RF/RMRS-97-052

**Closure Plan for Building 123
Components of
RCRA Unit 40**

September 1997

REVISION 0

Figure 1-1 Location of Building 123 and Associated IHSSs 121 and 148

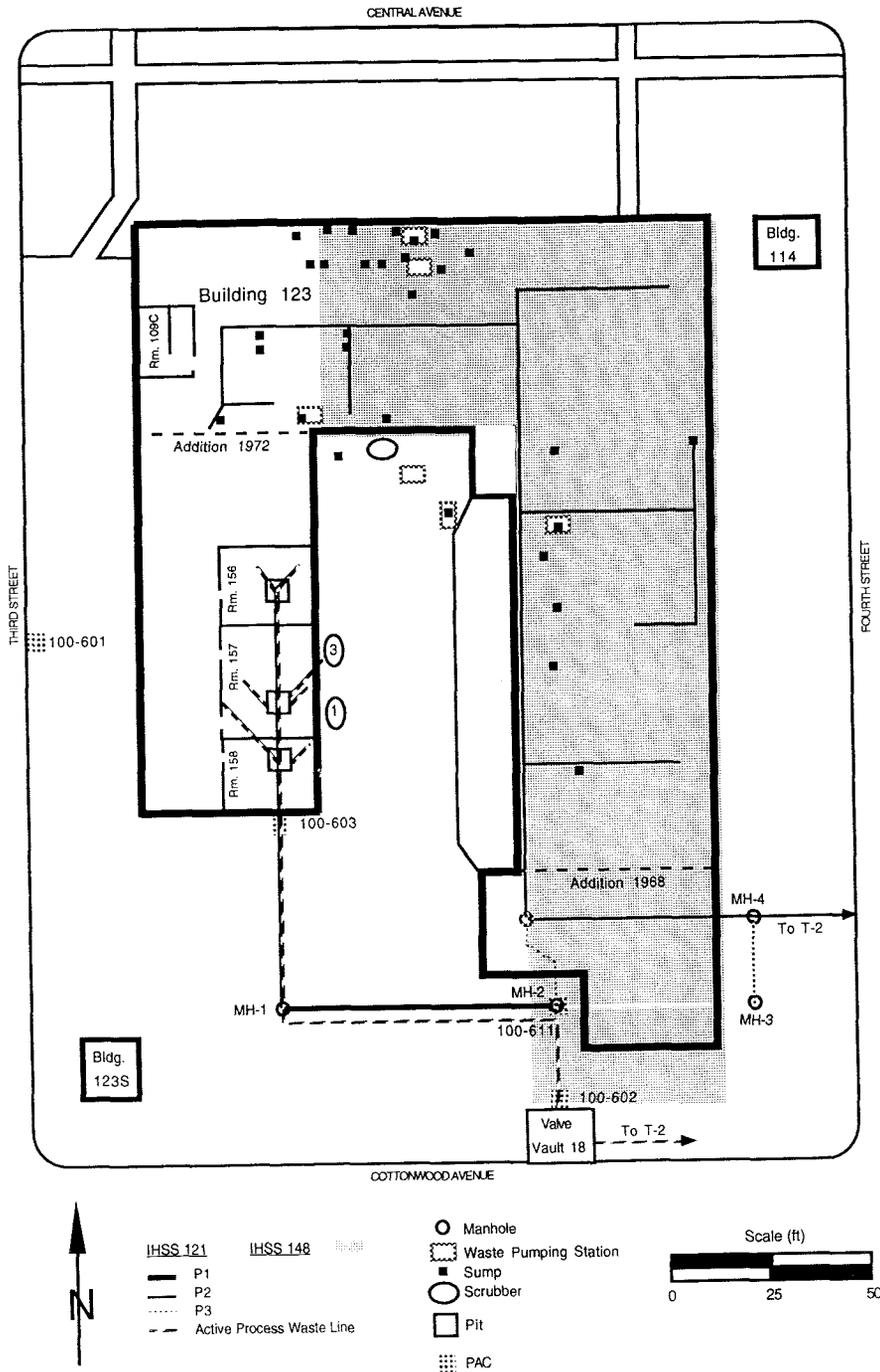
according to my notes and fig 1-1 the west wing was added 1972 an extension of the east wing was added 1968

July, August?
